Service Bulletins 1976-1978

**Rolls-Royce Silver Shadow,
Long Wheelbase,
Corniche and Camargue
Bentley T Series and Corniche
Rolls-Royce Silver Shadow II
and Silver Wraith II
Bentley T2**

TSD 4171

Service Bulletin Index for T.S.D. 4171

Figure 2 - Adjusting the expansion valve

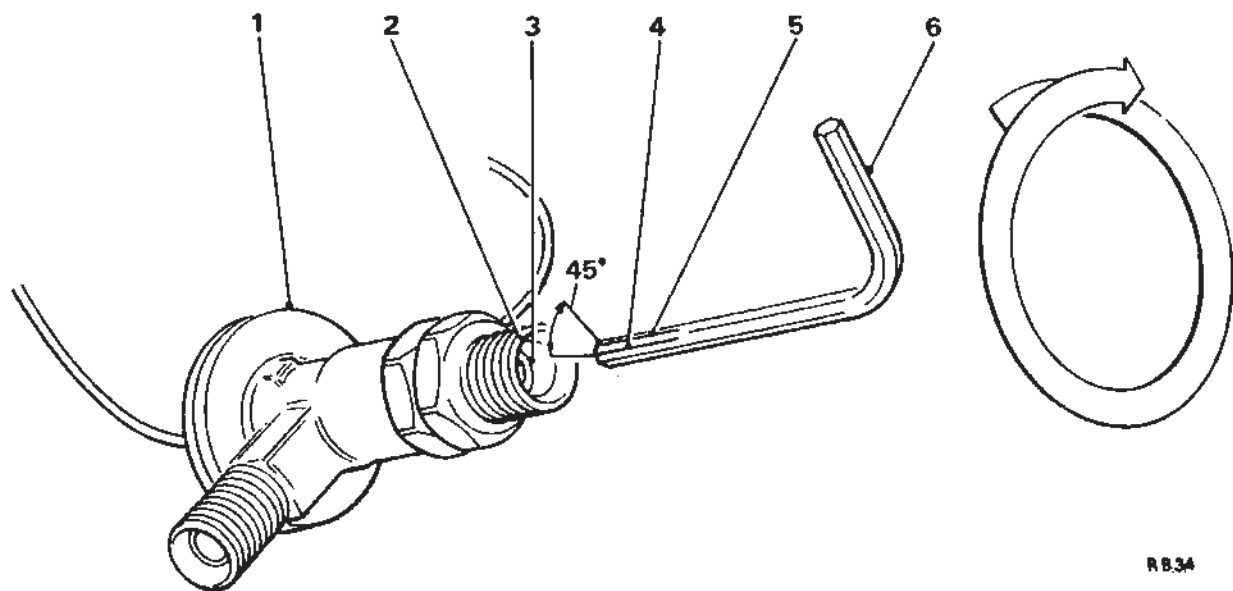
1. Discharge the automatic air conditioning system (see TSD 2939 - Workshop Manual - Camargue - Chapter C - Section C5).
2. Detach the outlet and inlet pipes of the expansion valve and carefully invert the valve. This allows access for the adjustment to be carried out. Ensure absolute cleanliness during these operations.
3. Obtain or manufacture a 9/32 AF Allen key as shown in Figure 2 and mark with two scribe marks, the first scribe mark representing one revolution of the key, the second representing 1 and $1/8$ revolutions of the key ($1/8$ turn represents 45° travel).
4. Insert the Allen key into the valve outlet port as shown in Figure 2 so that the key engages into the hexagonal adjuster. Scribe a mark on to the valve outlet port outer periphery to correspond with the scribed line, Item 5 of Figure 2.

Rotate the Allen key in a clockwise direction one full turn and then an $1/8$ of a turn so that the scribed line item 4 of figure 2 corresponds with the mark on the valve outlet port.

This operation means the hexagonal adjuster has been rotated 1 and $1/8$ turns clockwise.

Should the adjuster be rotated more than 1 and $1/8$ turns the valve must be renewed; on no account should the valve adjuster be turned anti-clockwise.

Fig. 1 Fuel pump with new mountings and breather system

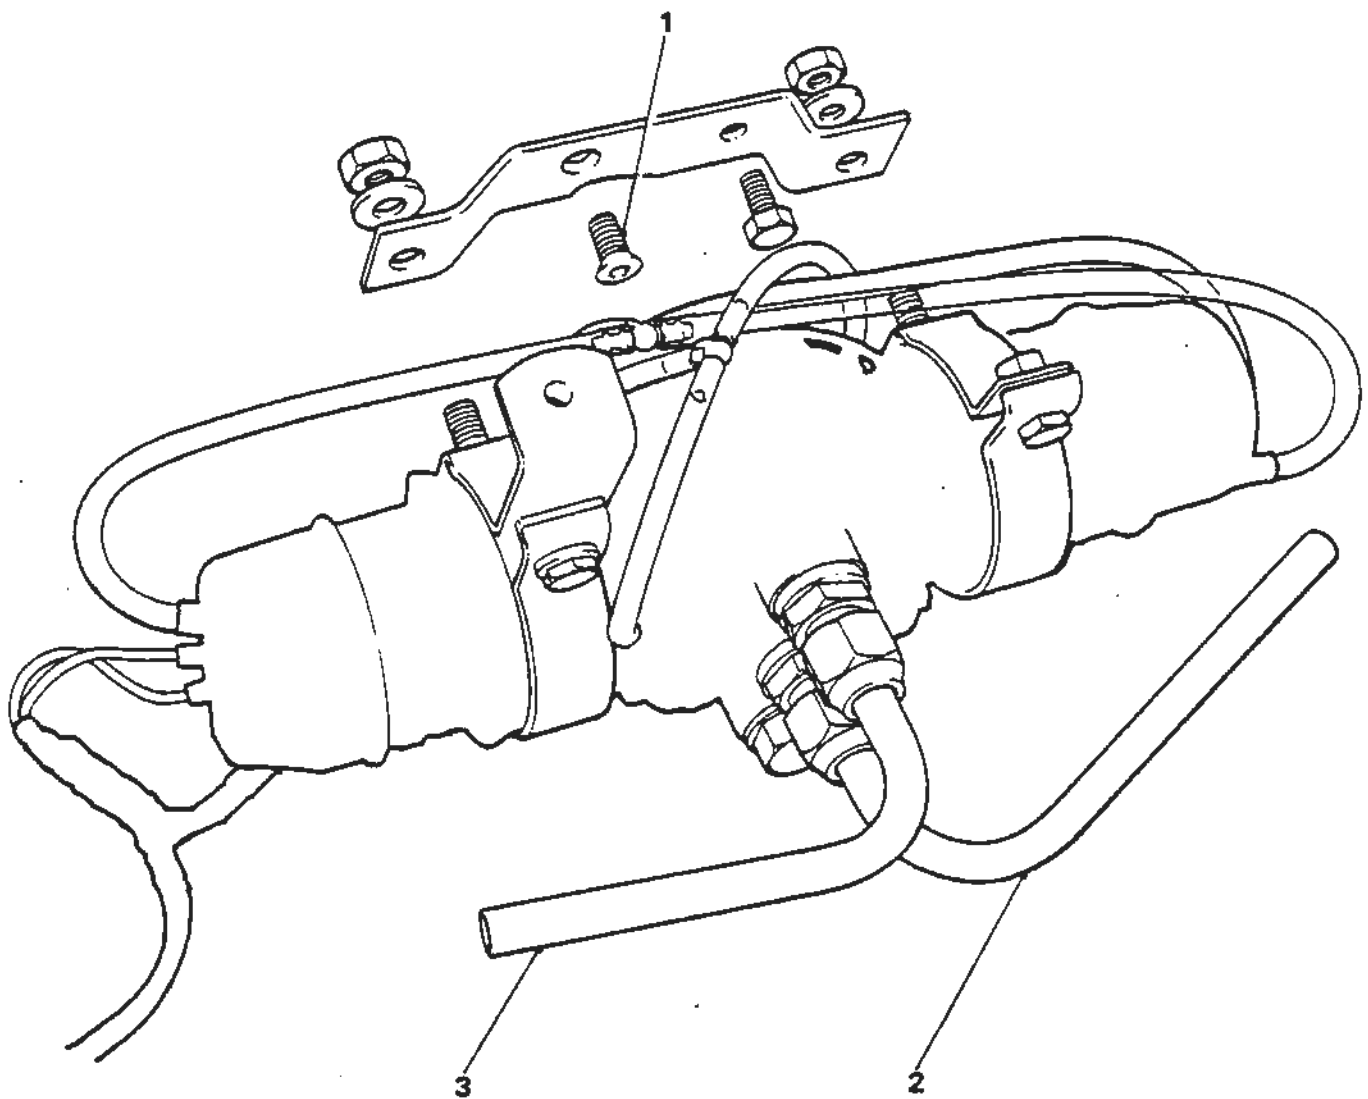
- 2.3 Release the two clamp bolts from the pump mounting brackets and remove both brackets and mounting rubbers from the pump. From the kit fit the new rubbers and mounting clips as shown in Figure 1.
- 2.4 Fit the right-angled plate and earth strap to the forward mounting clip leaving both the clamping bolts slack. Offer the mounting plate to the clip studs and rotate the pump within the clips so that the small hexagon headed bolt, situated in the centre of the rear of the pump, is positioned centrally in the scallop of the mounting plate and 1/16 in. to 1/8 in. from the scallop edge. This ensures maximum clearance between the pump and other components.

- 2.8 Connect the wiring harness supplied in the kit to the fuel pump. Ensure that the end of the loom with the capacitor fitted is connected to the front of the fuel pump and that the loom is passed above the pump.
- 2.9 The breather system is modified. In place of the four separate breathers entering the box section there are now only two; this is achieved by the use of 'Tee' pieces from the kit (see Fig. 1).

Figure 1 - Renewing limit switches

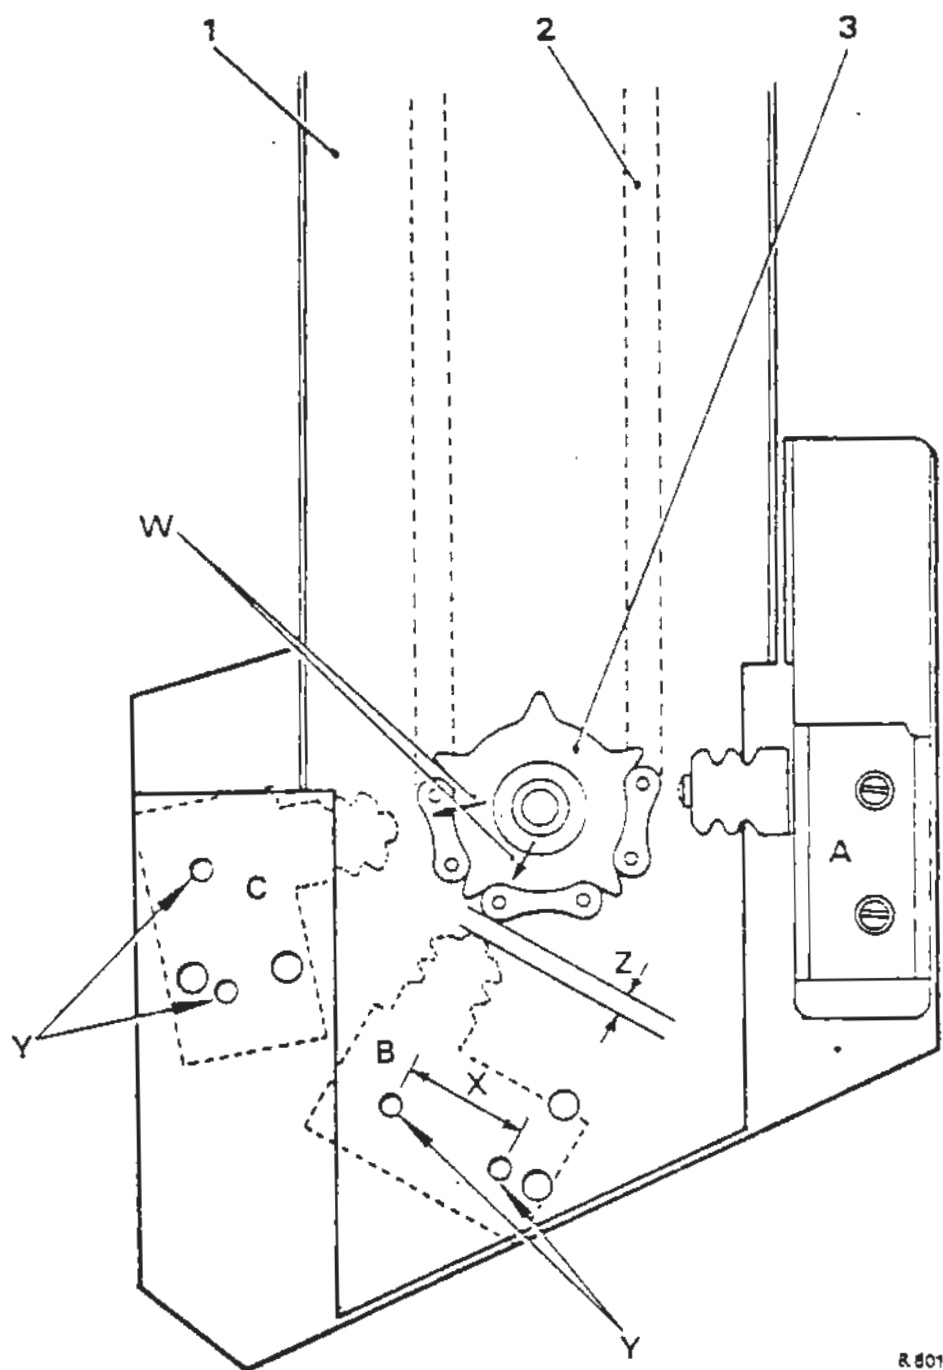
Figure 1 shows the new UG 4049 switches fitted to the window lift assembly. However, variances of the window lift motor assembly are available i.e. opening rear quarter light, but the same general principles can be applied to all cases in the positioning of the switch.

- 1 Using Figure 1 as a guide, mark the centre line of the existing switch (PW 11120) plunger on to the lower sprocket.
- 2 Remove the faulty switch.
- 3 Using Figure 1 as a guide, mount the switch allowing 2,8mm. to 1,4mm. (0.100in. to 0.050in.) clearance between the stainless steel switch plunger and the chain. No part of the switch should overhang the base plate.

- 6 The wiring remains unchanged. Cables to switches B and C (see Fig. 1) are attached to terminals 1 and 2 marked on each switch.

Figure 1

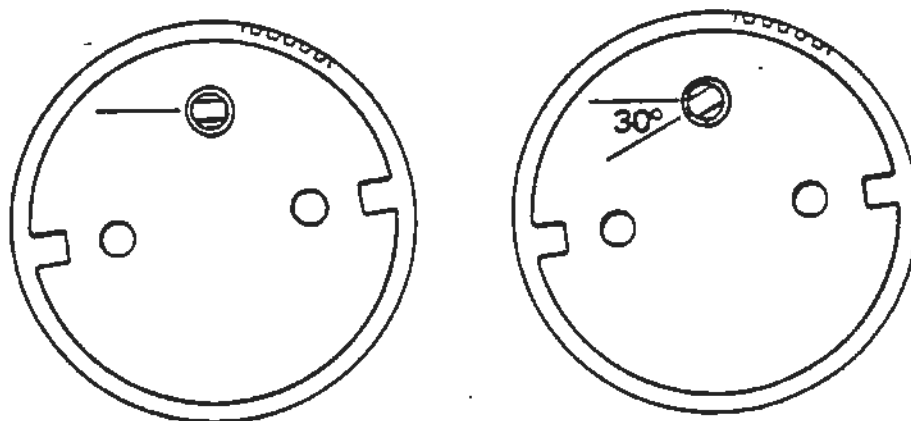
- 1 Unscrew the rack tube nut and release the clamp from the wiper motor.
- 2 Rotate the motor until the parking switch is accessible (see Figure 1). Tighten the rack tube nut. This will allow the motor to be operated and also permit adjustment of the switch.

- 4 Carefully move the limit switch outwards to a position where the motor will reverse and move the blades to the correct parking position. Scribe a line on the motor casing at this point as shown in Figure 1.

- 5 Move the limit switch 0,51 mm (0.2 in.) further outwards from the scribe line and tighten the switch securing screws.
- 6 Switch off the ignition and re-fit the wiper motor to the mounting bracket.

FIGURE 1 - WIRING DIAGRAM

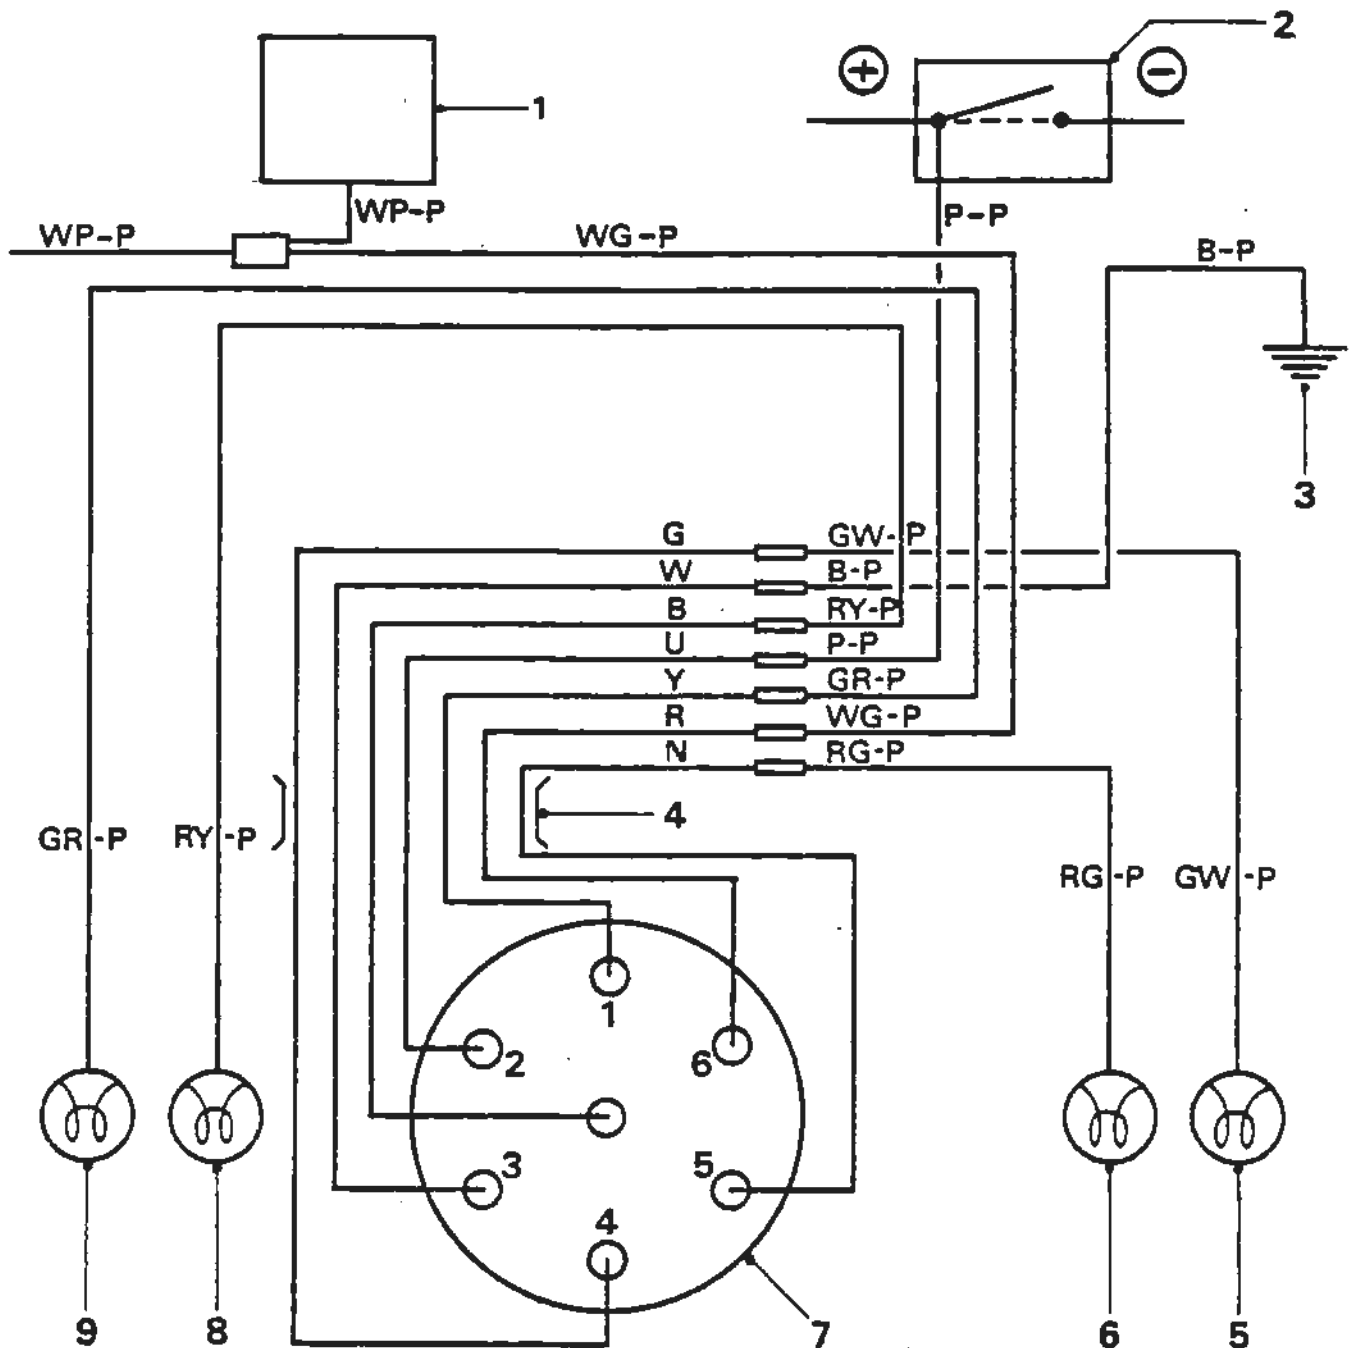
Figure 1 illustrates the wiring and terminations of the additional wiring described previously.

Take the seven core cable of the proprietary plug/socket being fitted to the car (see figure 1) through the grommet previously fitted and connect the cables as given in the following table.

FIGURE 2 - FITTING ADDITIONAL FLASHER UNIT AND SWITCH

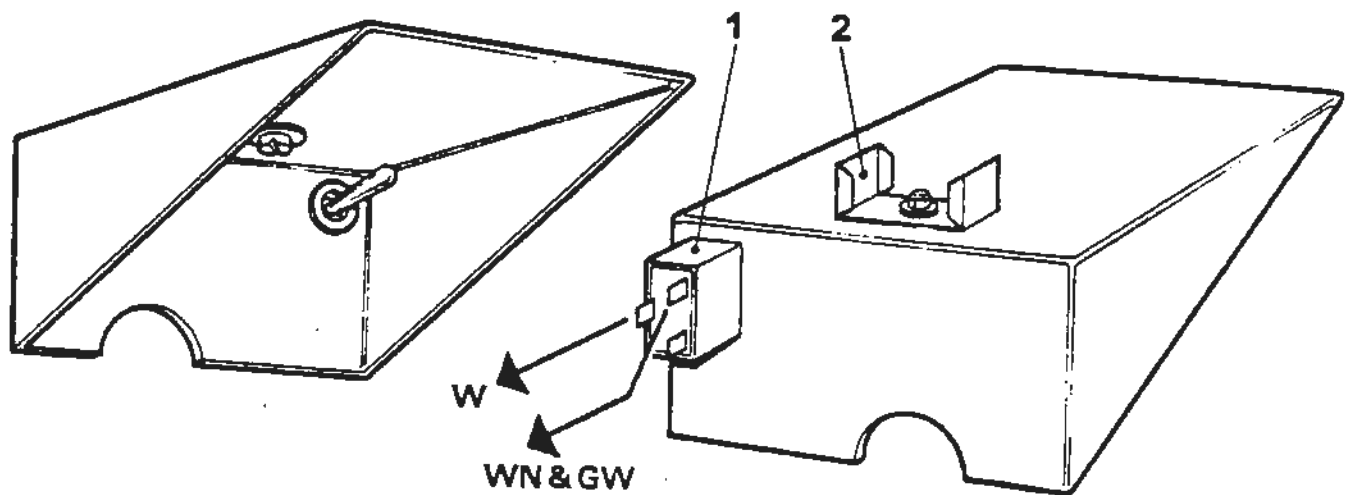
- 1 Lower the fuseboard.
- 2 Remove the handbrake surround trim securing screws (3) and remove the trim.
- 3 Separate the fuseboard from its support assembly.
- 4 Using Figure 2 as a guide fit a UD 15249 switch ('off' position uppermost) to the top right-hand corner of the front facing vertical panel. Ensure the off-set terminal is to the left when viewed from the front of the car.
- 5 Fit mounting bracket UA 8982/Z (required for an additional 'Lucas' flasher unit (direction indicators) 8FL type 53) onto the top of the handbrake surround trim as Figure 2. Secure the mounting bracket with suitable chromed headed bolts ensuring that the bolts are sufficiently shortened to prevent them fouling the flasher unit.

FIGURE 3 - WIRING ADDITIONS IN FUSEBOARD AREA

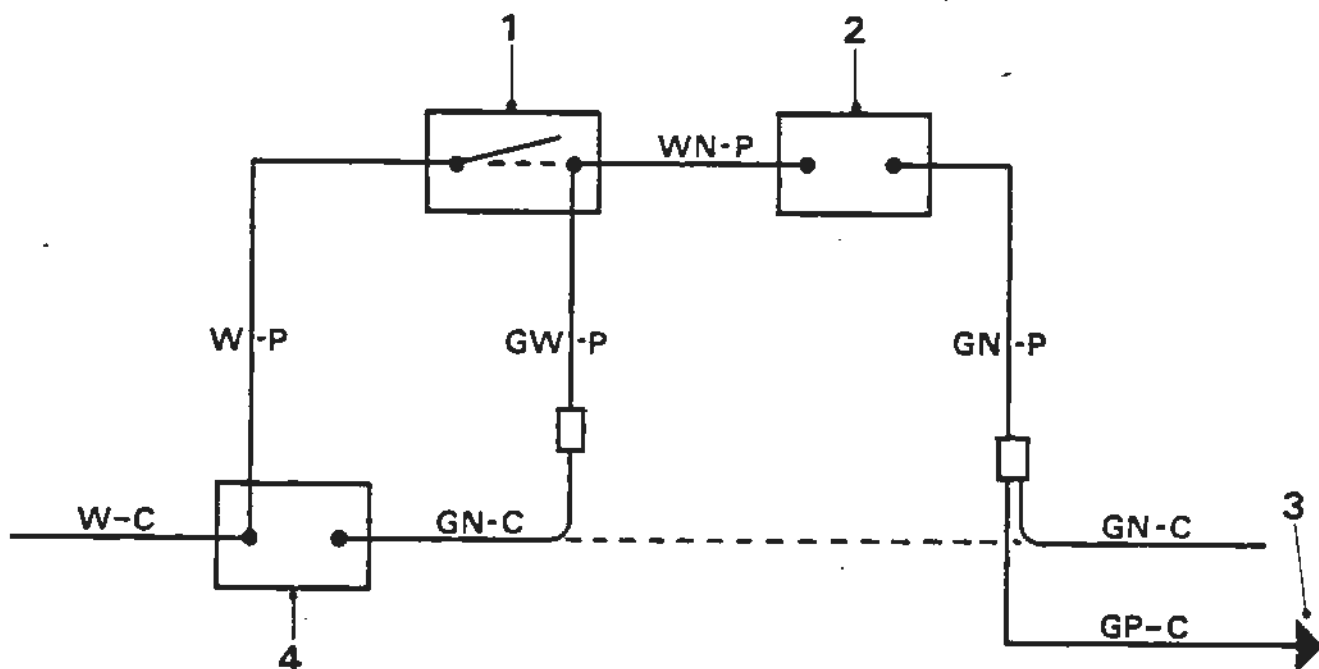
- 1 Using Figure 3 as a guide break the GN-C cable and solder female Lucar connectors to the bared ends.
- 2 Take a GW-P cable fitted with female 'Lucar' connections from the flasher unit end of the GN-C cable. Route this cable to terminate above the handbrake.
- 3 With a suitable connection connect the remaining end of the GN-C cable to a GN-P cable and route this to terminate above the handbrake.
- 4 Connect a W-P cable to a W-C cable at the flasher unit terminal and take the remaining end to terminate above the handbrake.

Figure 1 - Wooden spacer blocks in battery box

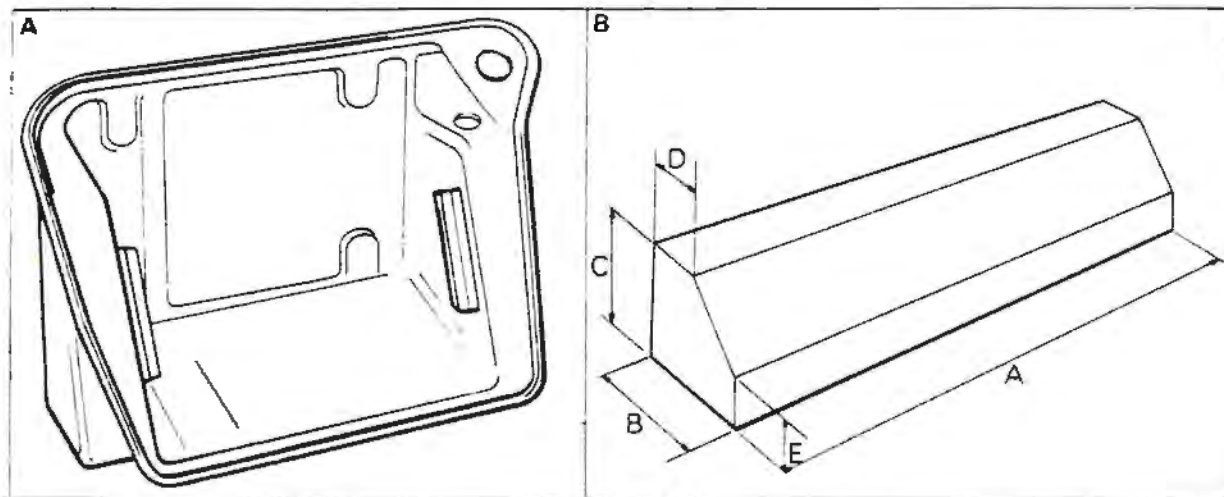
- 1 Remove the trim panel, tool tray, battery box cover and luggage compartment floor covering.
- 2 Disconnect the battery connections and remove the battery clamping plate and battery.
- 3 Secure the two locally manufactured wooden spacing blocks (see Fig. 1 inset B) to the sides of the battery box as shown in Figure 1 inset A, with a suitable impact adhesive.
- 4 Fit the new Chloride battery. Connect the battery connections and fit the battery box cover, tool tray, trim panel and floor covering.

Figure 3 - Fitting Relay to Servo Bellows Bracket

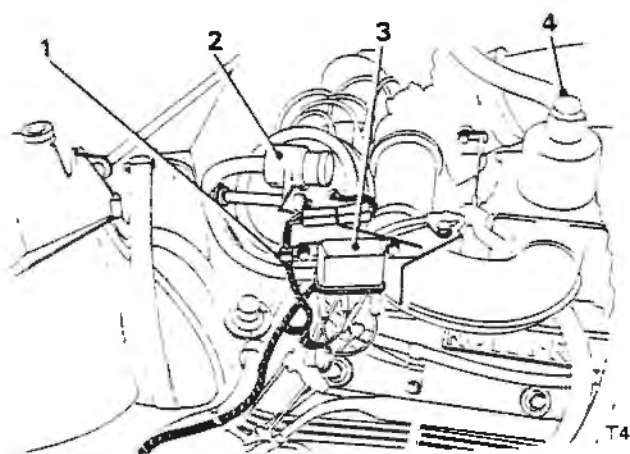
- 1 Fit UD 9270 relay provided to the speed control bellows mounting bracket, utilising the 2BA setscrews, washers and nuts provided as shown in Figure 3.
